UNAUTHORISED REMOVAL OF STABILISER LEGS

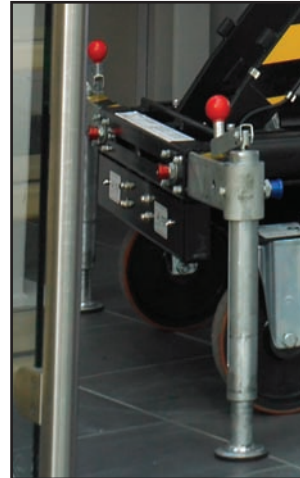
WARNING:
The stabilisers on Pop-Up Plus should only be used as shown in the above picture. The stability of the machine will be affected if they are not deployed fully or not deployed at all i.e. removed.

Therefore the removal of the stabiliser arms is viewed as a deliberate act that will affect the stability of the machine whilst in use and as such, should be deemed an act of gross misconduct. Pop-Up Products believe that if further prevention of removing the stabiliser arms is possible, it should be carried out. We have therefore released a Security Bolt Kit, which is available free of charge. Pop-Up Products will be dispatching these kits to Pop-Up Plus customers and all new machines will feature the security bolt from this point onwards.
